HARTING Product Change Notification

Business Unit: Electric
Product range: Han / Han D
Author: Maik Iphoefer
Title: Han D Female 2

PCN/19/013/C+N
Date: 2019-06-18

New Version: Han D[®] Female 2.5 mm²

Details of Product Changes

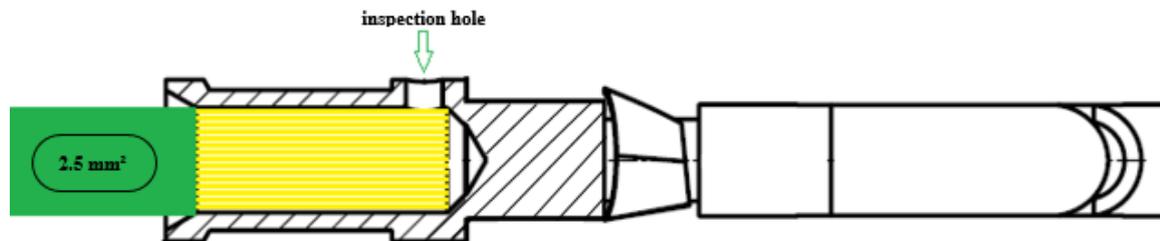
Due to an improvement of our production process we will change the location of the inspection holes on the products with the part numbers mentioned above.

This change has no influence on the electrical characteristics or processability of the contact.
